DeKalb County Historic Preservation Commission

Staff Report

- I. 1146 Lullwater Road, David Price. Demolish a non-historic garage, construct a two-story addition at the rear of a non-historic addition and a porte-cochere on the rear right corner of a historic house, and install a pool in the rear of historic property. **1248227.**

Built in 1925 (18 002 06 071)

WEGMAN RESIDENCE
1146 LULLWATER RD
ATLANTA, GEORGIA
MAIN LEVEL
FLOOR PLAN
SHEET A-1
JULY 15, 2026

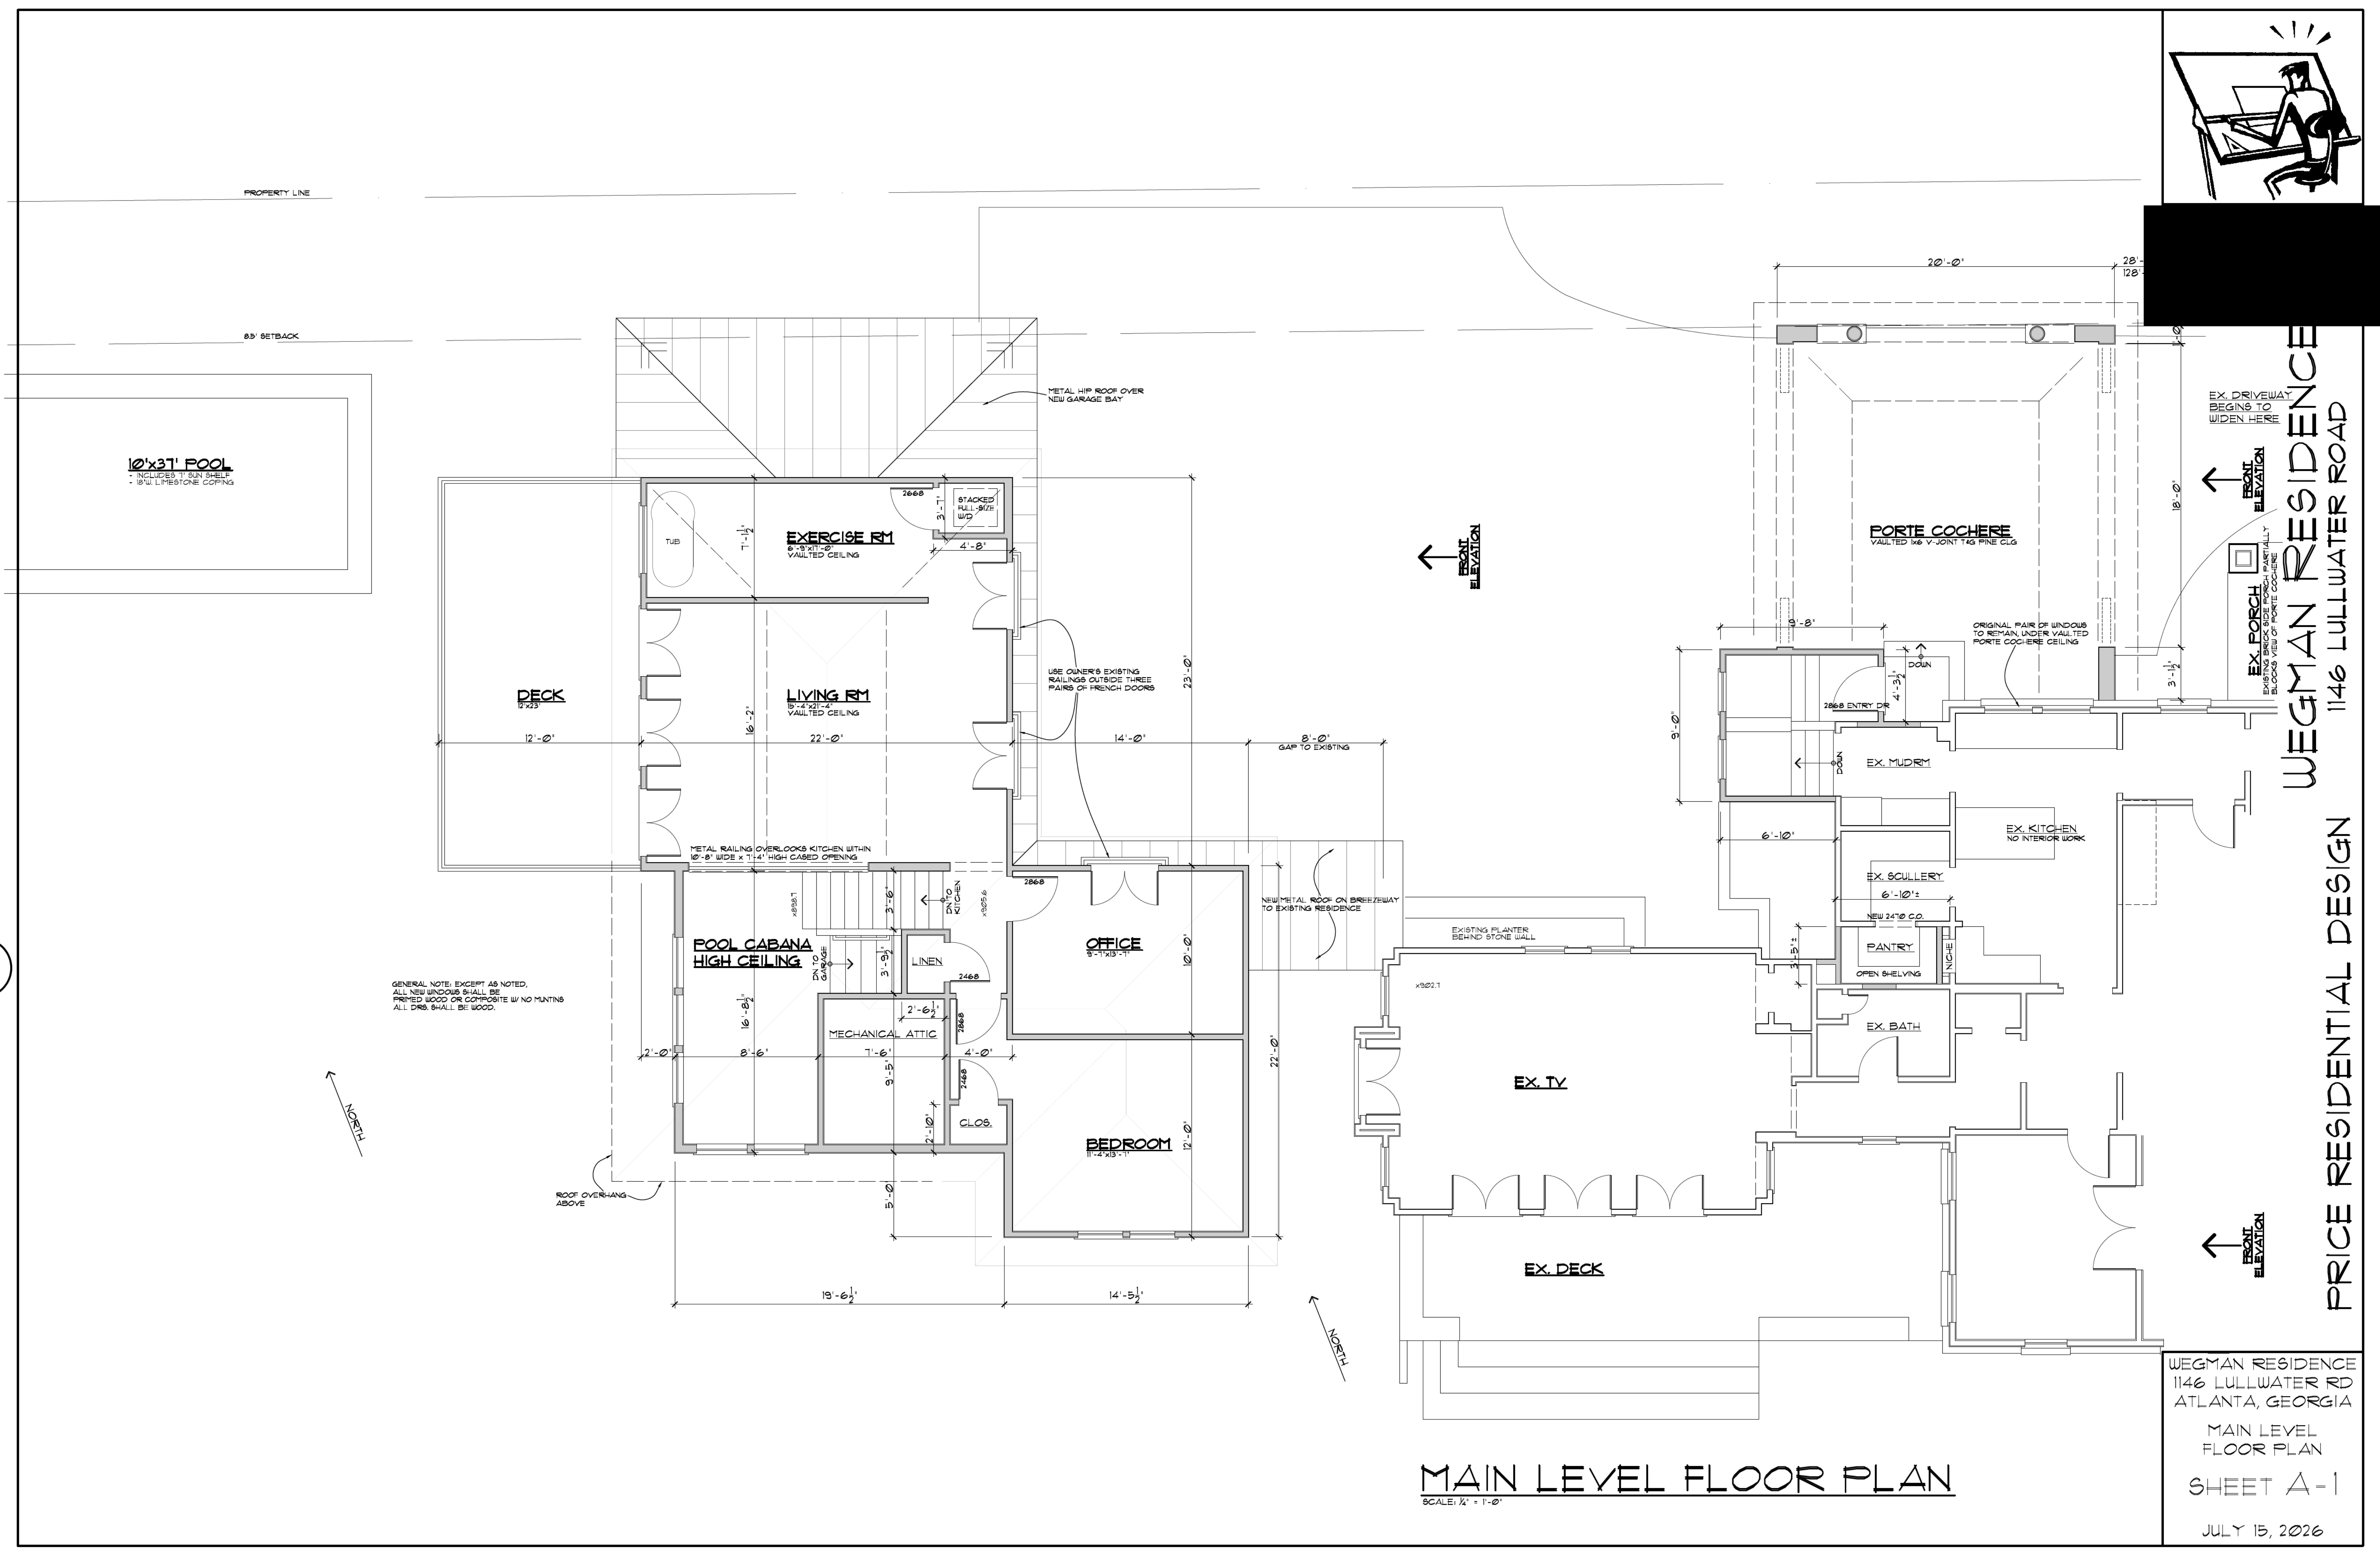
Will the driveway be expanded or modified in any way? If so, how? The main floor plan, sheet A-2, shows a dashed line marked as "existing garage location" and that dashed line continues forward toward the new porte cochere. That portion of the line is the existing edge of the driveway and the new driveway will be expanded 6.25'+/- towards the north lot line in that area (stopping approx. a foot short of the lot line). The grade drops towards the lot line so that northern edge of the driveway will be 16"-18" out of the ground with a concrete curb for cars and to direct water to area drains, which the northern neighbor loves. Other than that the driveway is largely the same (it is at the same elevation) as the existing one, which was quite large. It is proposed to begin widening as it passes the rear corner of the existing side porch, to reach over to the new entry stairs under the porte cochere. We may begin the replacement of the concrete at the front edge of the side porch but that would be a simple replacement in the same location and width (until it begins to widen at the rear of the porch). The new driveway will be concrete, matching the existing concrete driveway in the front yard.

PROPOSED PORTE COCHERE FRONT ELEVATION
SCALE: 1/4" = 1'-0"

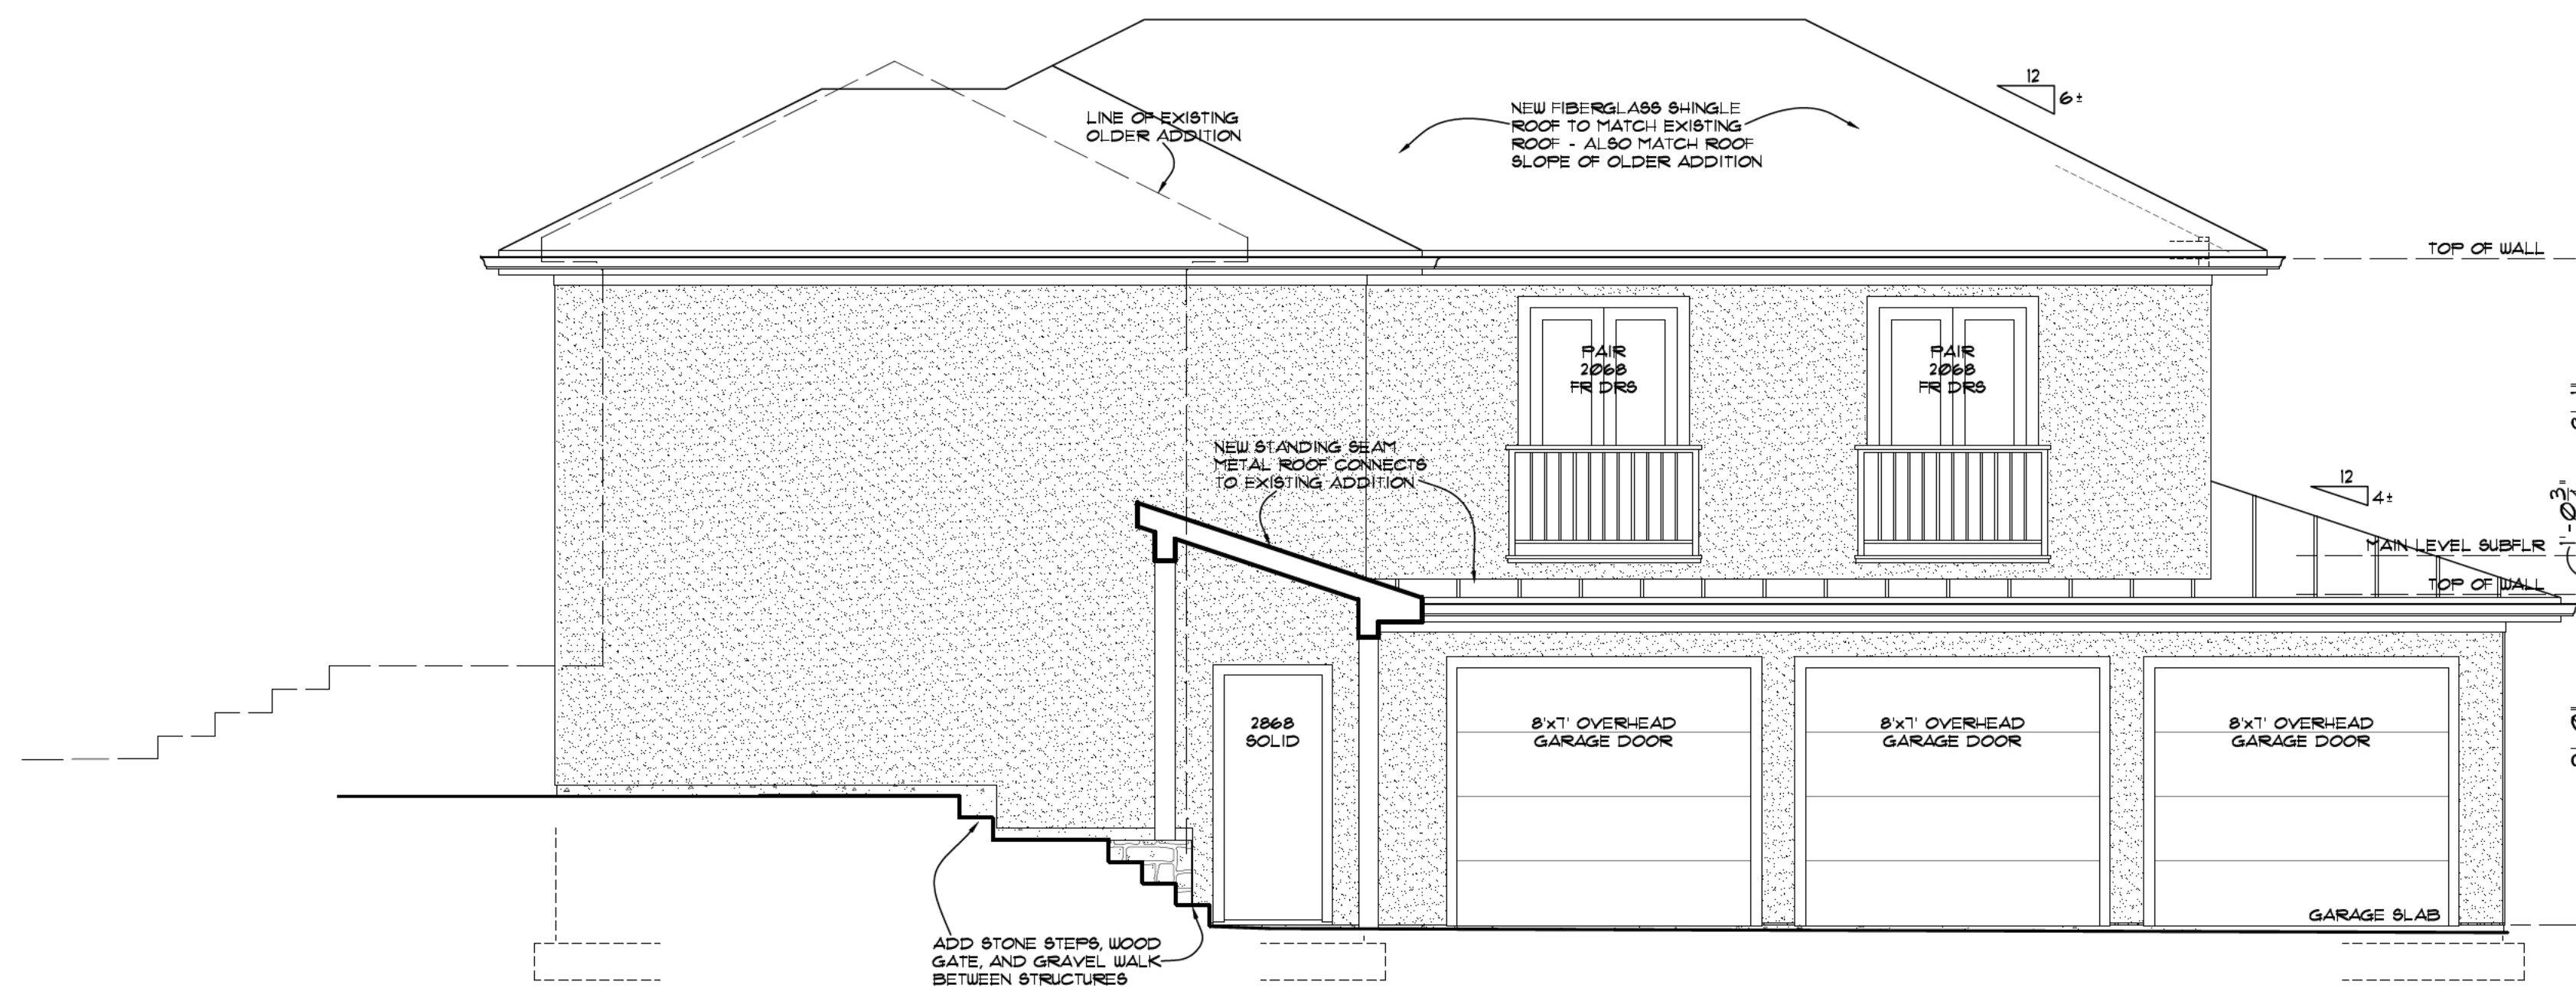
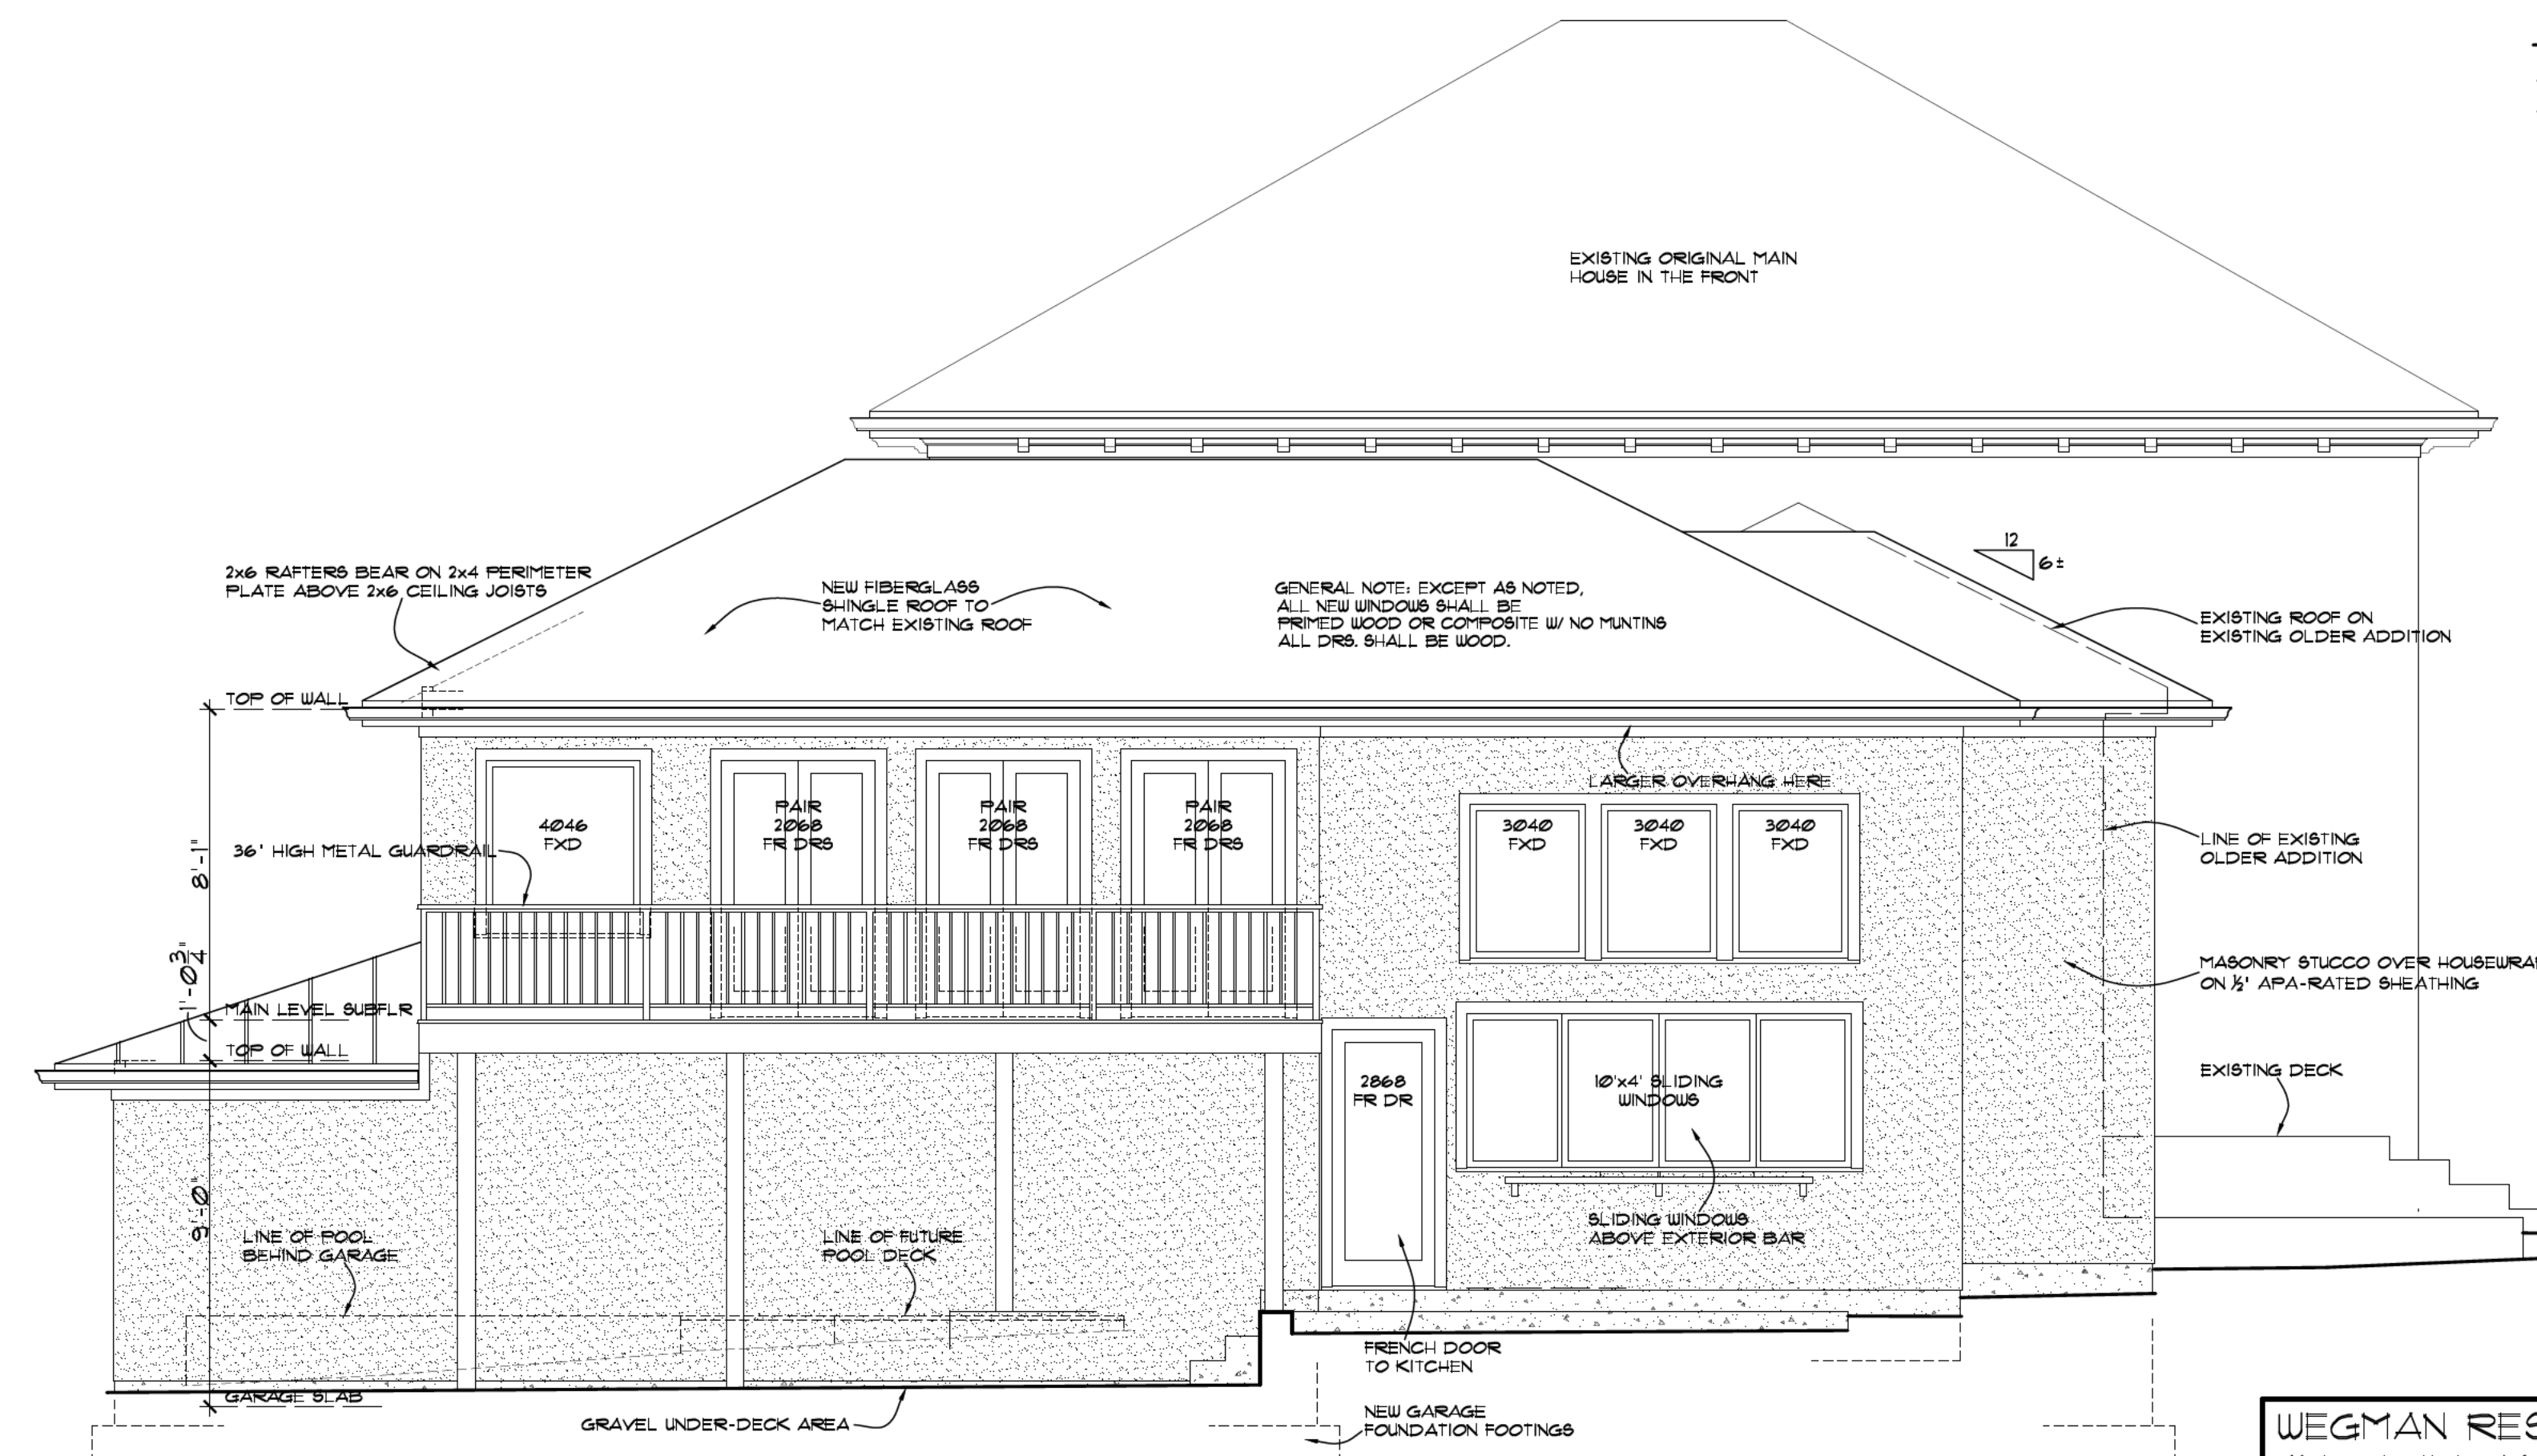
3. Construct a porte-cochere on the right rear corner of a historic house. A porte-cochere structure will be constructed on the right rear corner of the historic house, over the existing driveway. The porte-cochere will be constructed with a hipped, standing seam metal roof and masonry, stucco siding. Doric columns will be installed on the structure as decorative elements. The porte-cochere will extend roughly 22' from the façade of the right elevation of the historic house and will measure roughly 18' from grade to roof ridge; this will extend 16" above the roof the existing screen porch.

Approve with Modifications. Staff recommend that the application be approved with the modification that the proposed porte-cochere be denied in accordance with Guidelines 6.1.2 and 7.3.1, as porte-cocheres are important, architectural elements of the Druid Hills Historic District⁸ and the construction of nonhistoric porte-cocheres on historic properties where there were no porte-cocheres is adding false historic details and creates a false sense of history.⁹

What is the height of the proposed porte-cochere from grade to roof ridge? There is a slight slope but from the mid-point of that slope up to the ridge is 18'-2". That new ridge is 16" above the roof of the screened porch in front of it and 17.5' lower than the main house ridge.
